PARKER AND PINE FILING NO. 1 LOT 2 – SITE PLAN

MURPHY OIL USA, INC.

SITE PLAN DOCUMENTS

COVER SHEET
MURPHY EXPRESS
12405 SOUTH PARKER ROAD
PARKER
COLORADO

C-0.0

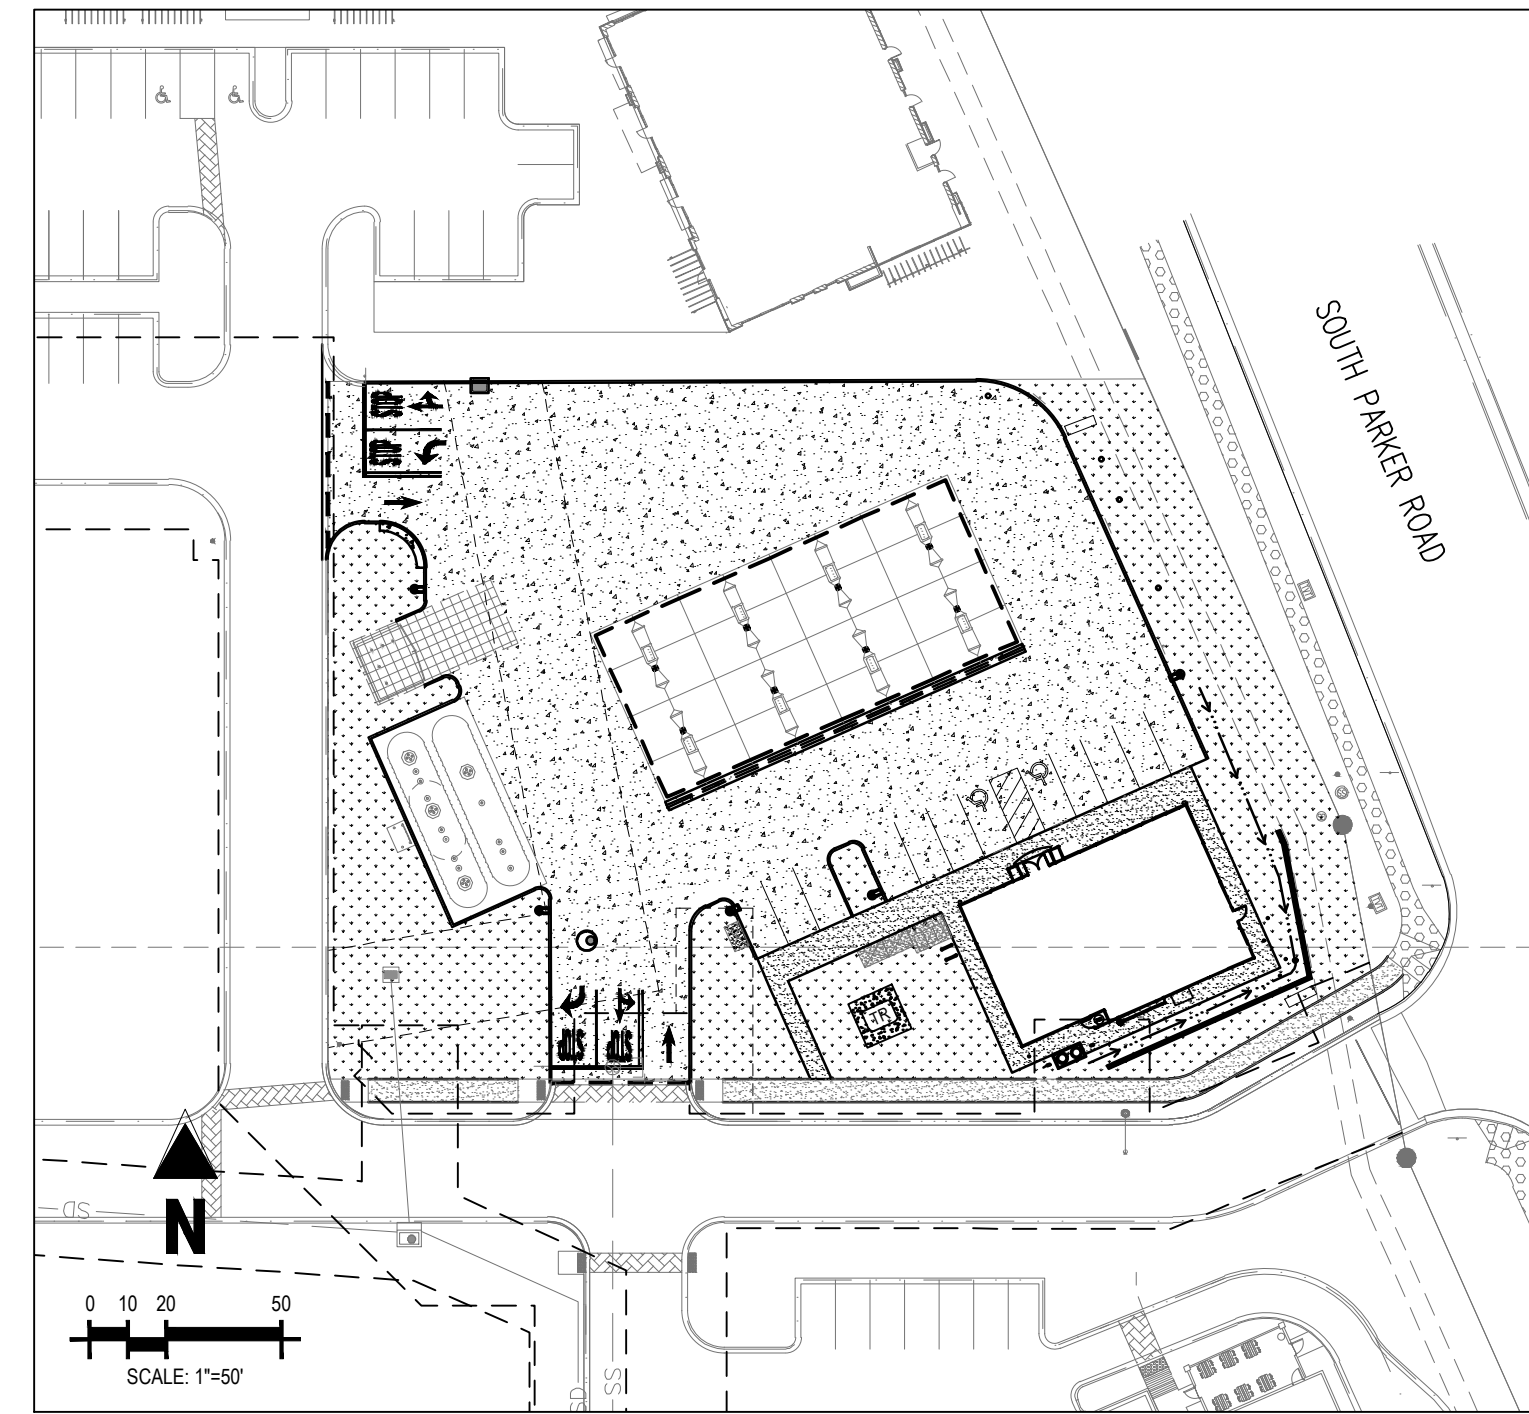
Please add 'Required & Provided' per the Parker & Pine PD and reflect the correct setbacks (e.g.: East: Min. 10', Maximum 80' from curb)

Please cite calculation

Statement is for Construction Documents/set only.
please remove from Site Plan set.

4 LANDSCAPE SCREEN WALL SCALE: NOT TO SCALE

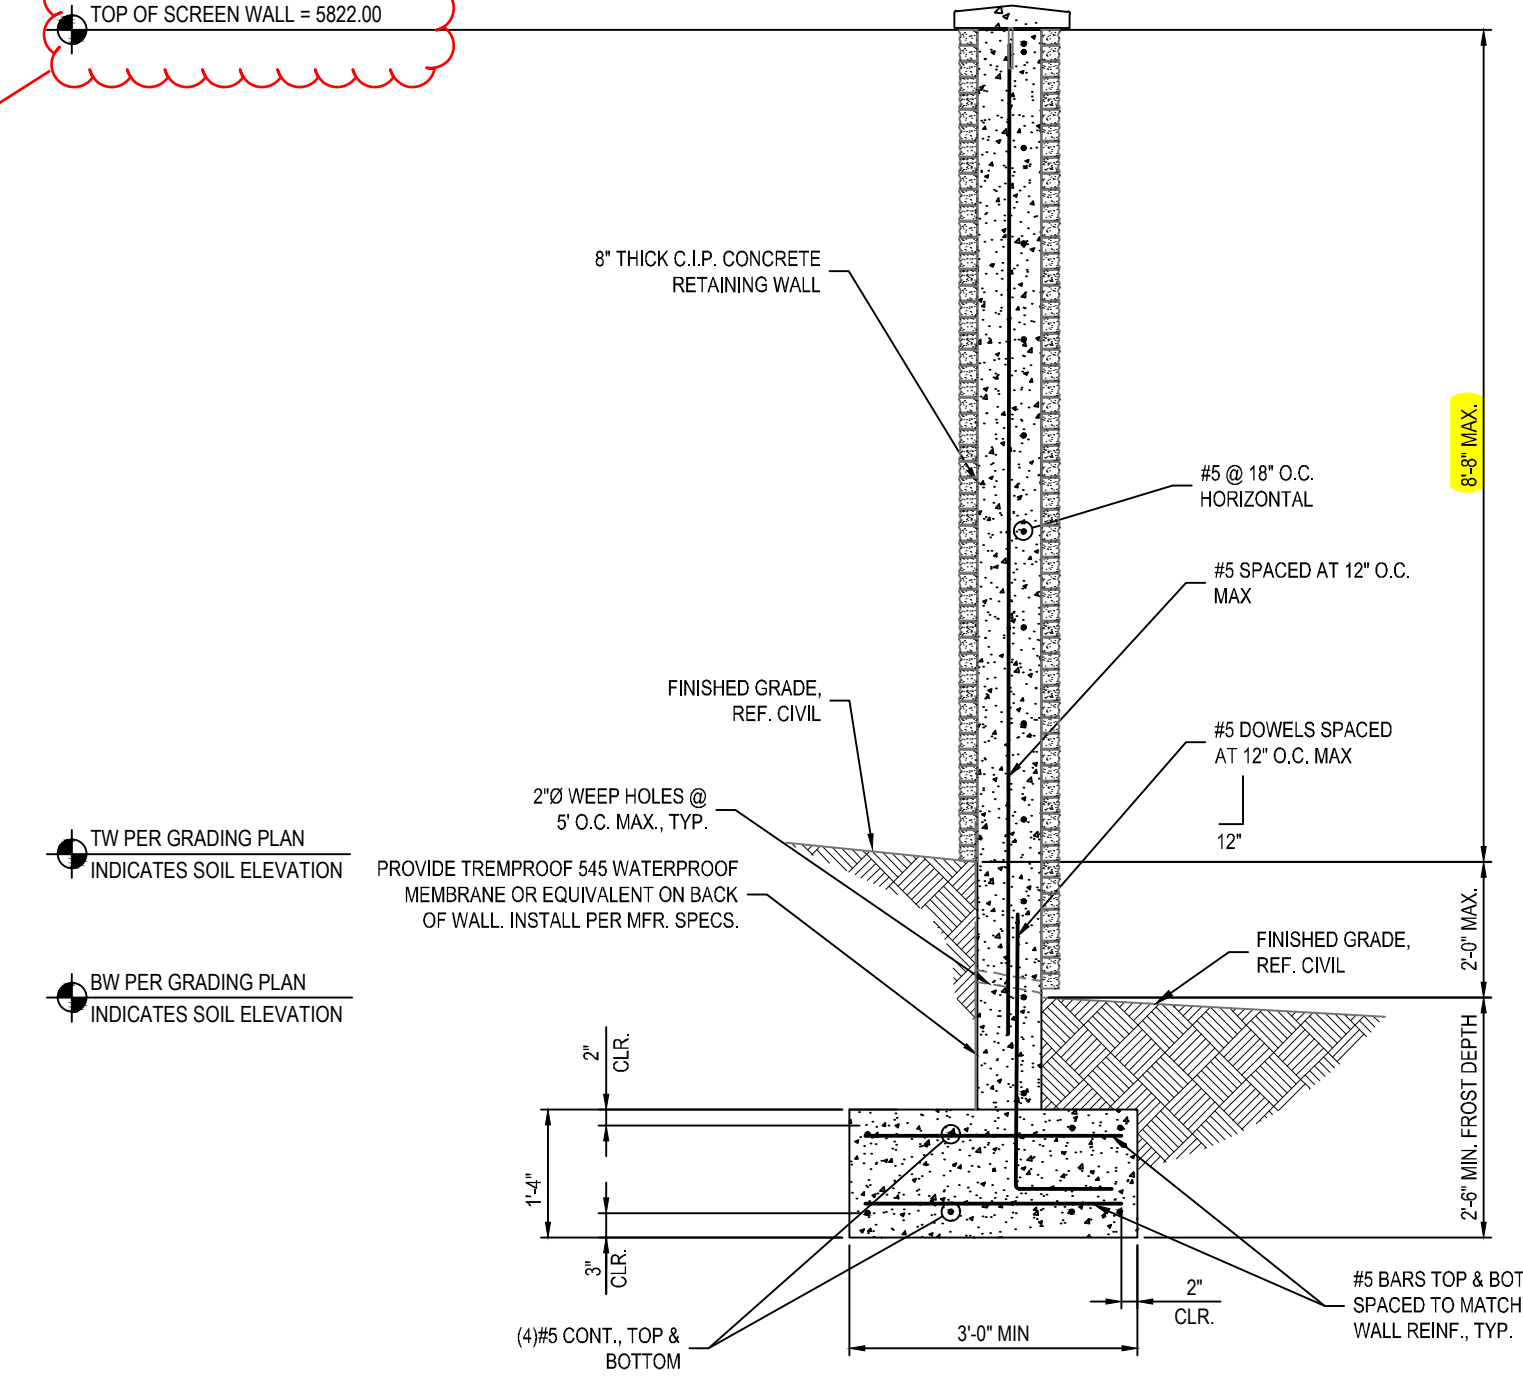
Please show on renderings where this screen wall is. 8 foot tall screen wall is too tall and a security issue & probably not allowed by IREA. Please coordinate with IREA on their screening requirements.

2 RIGHT ELEVATION (SOUTHWEST)

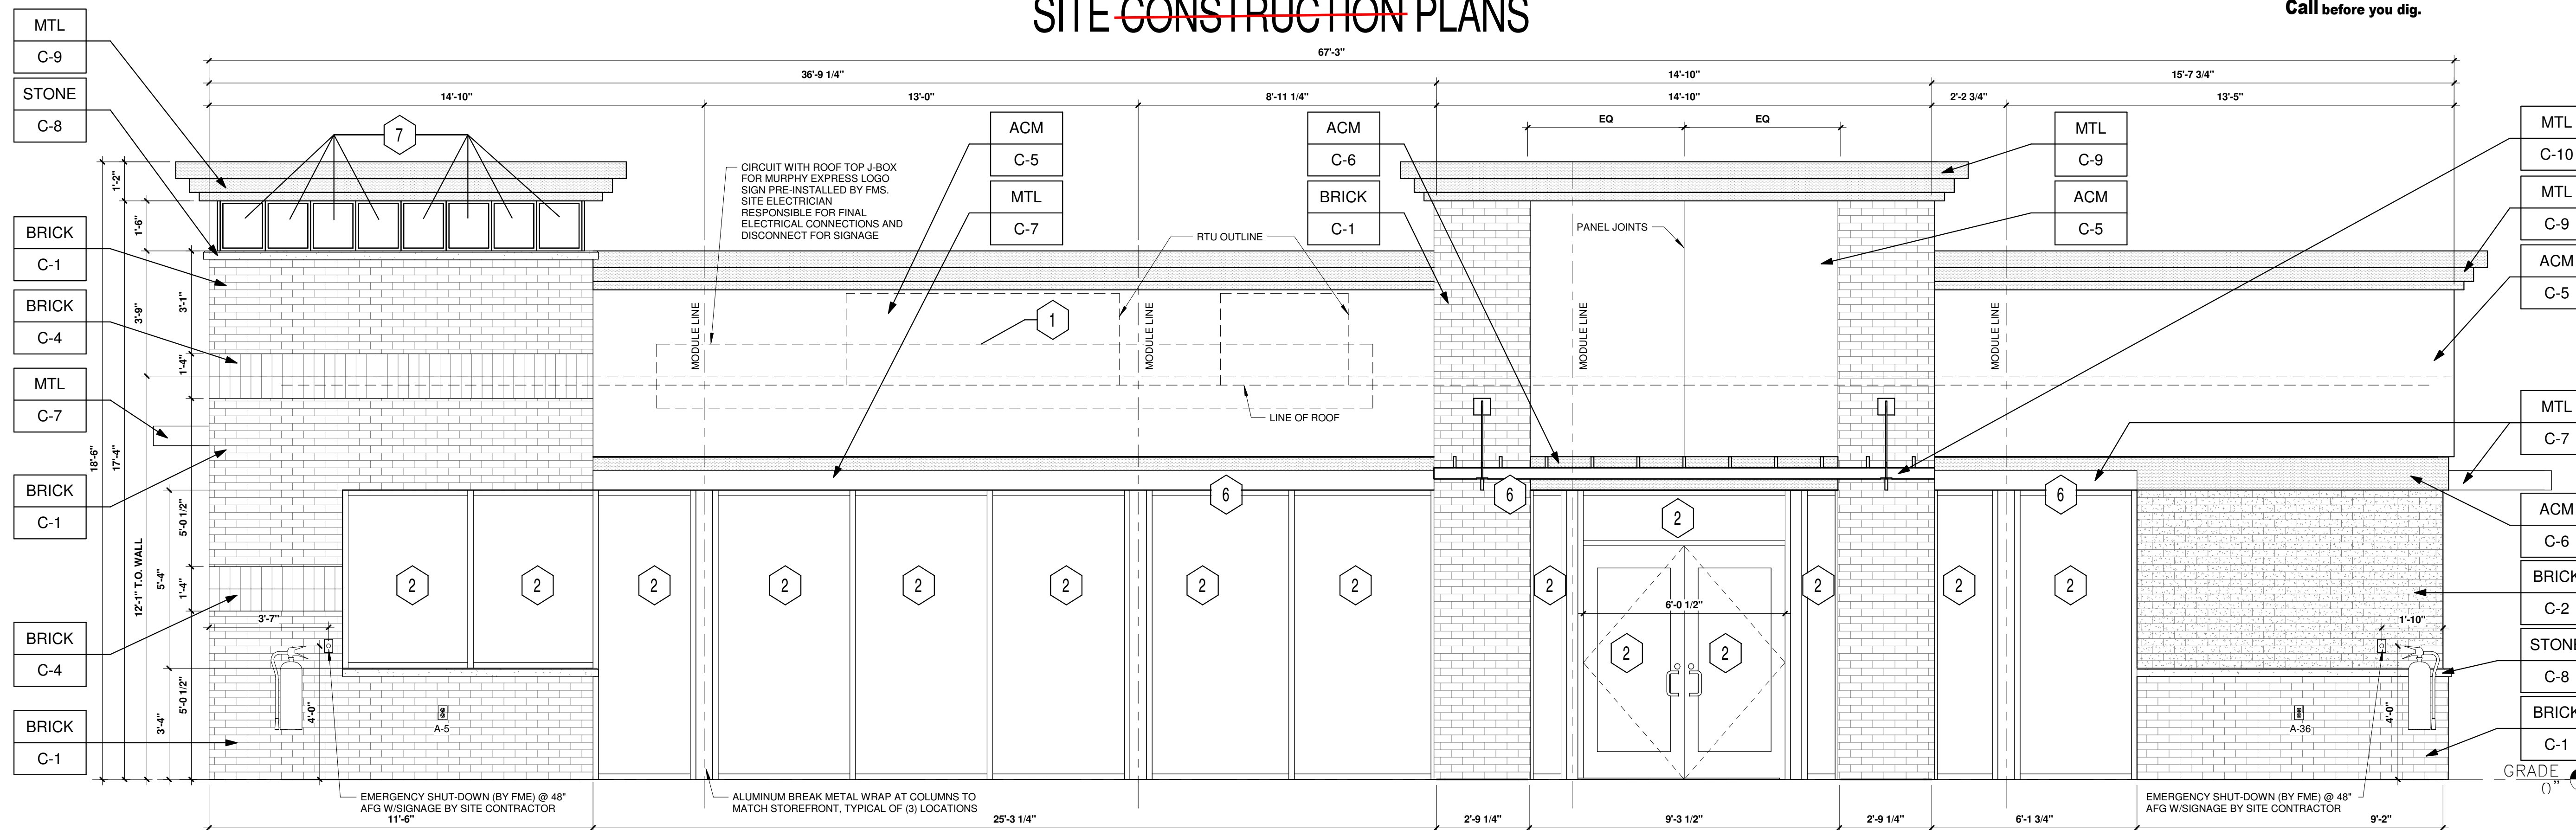
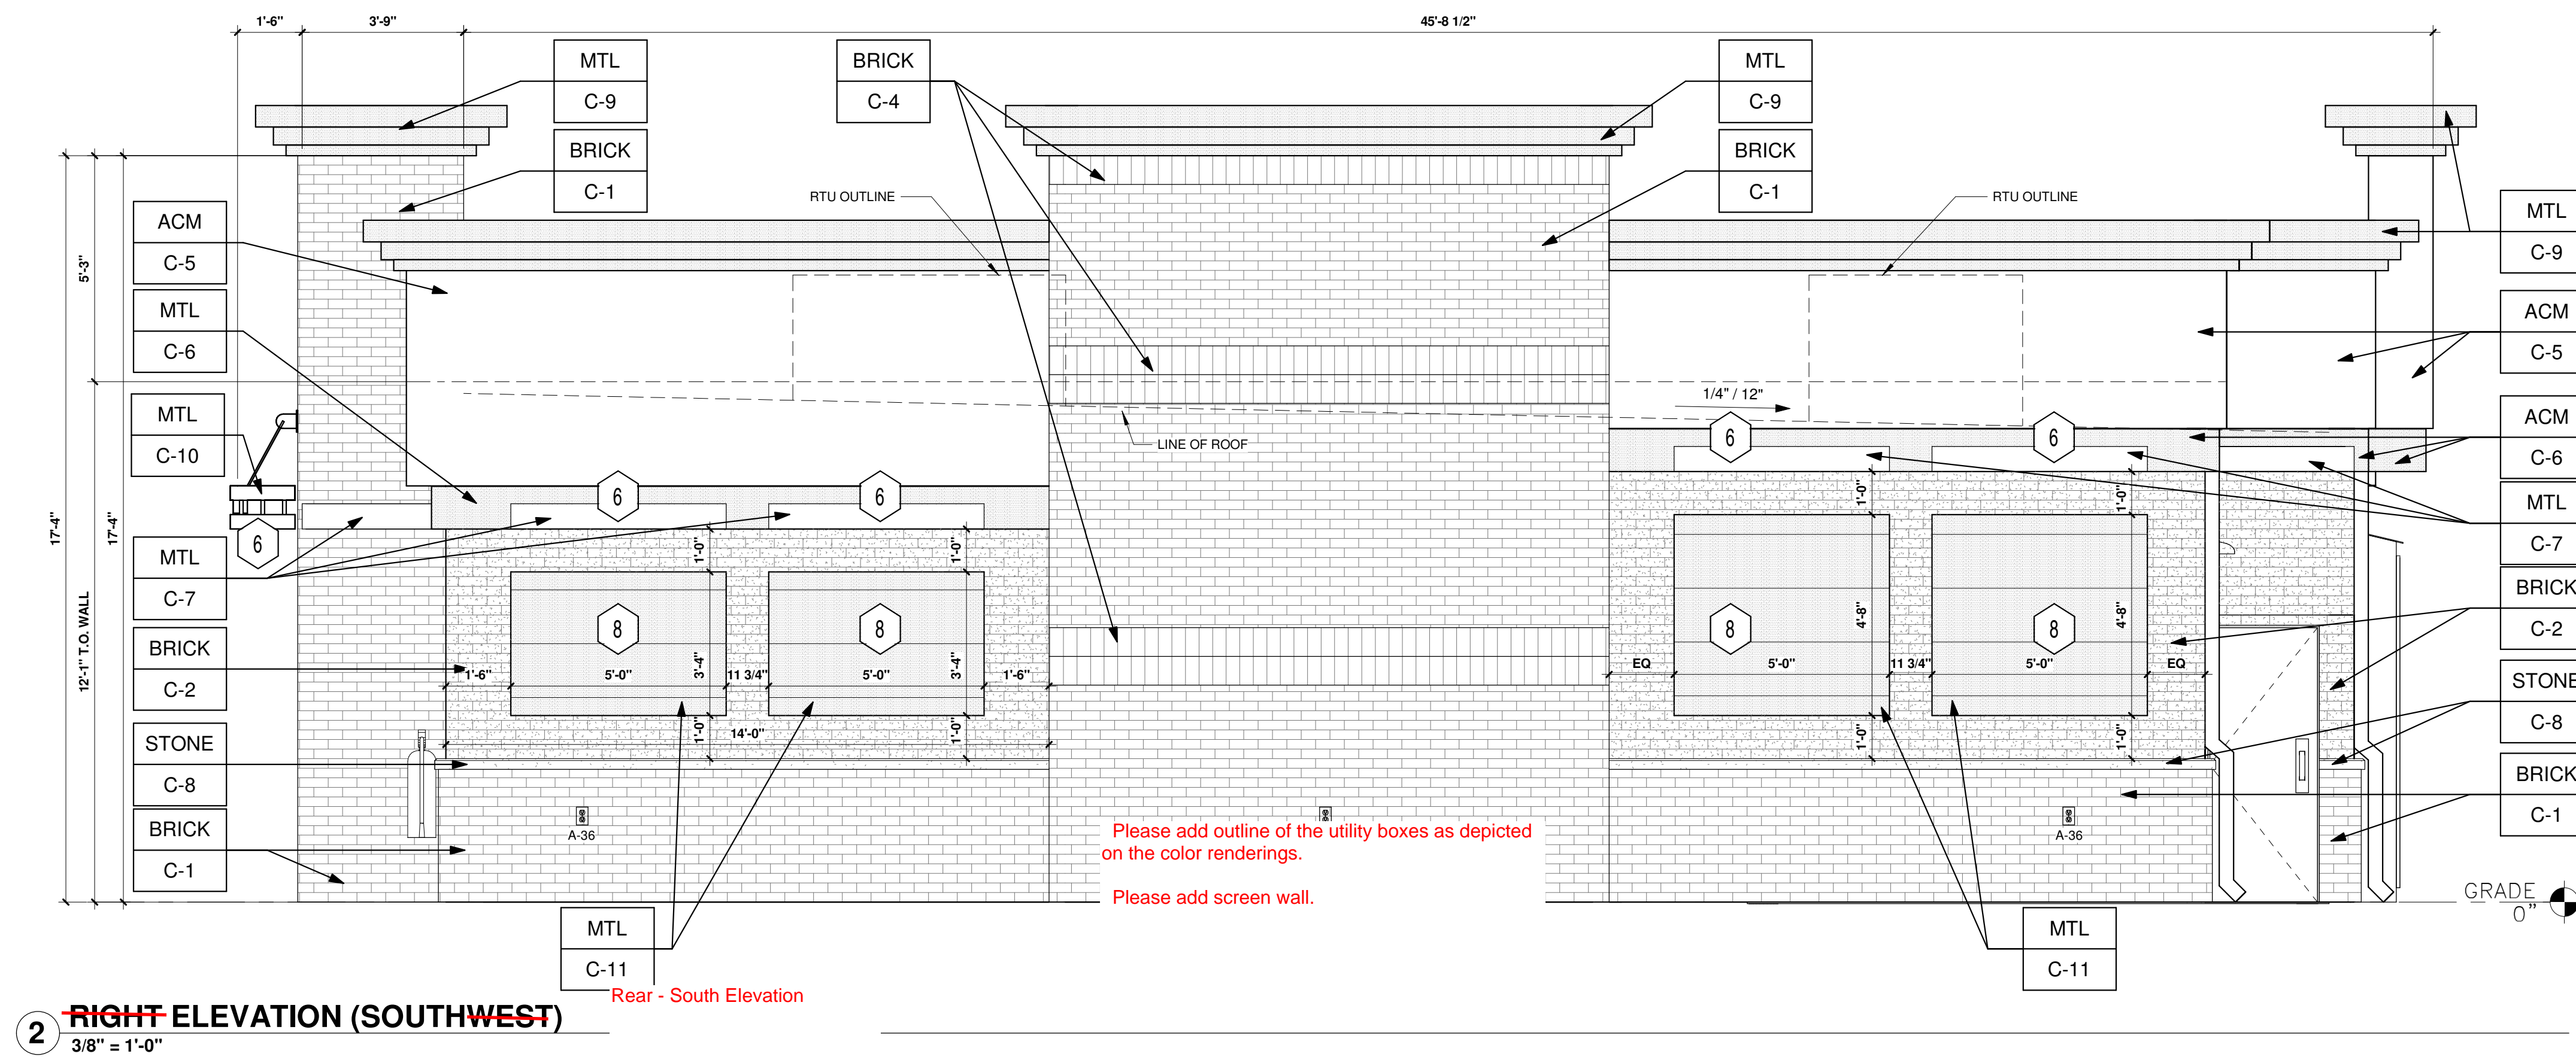
Add/show bike racks at front/primary entrance.
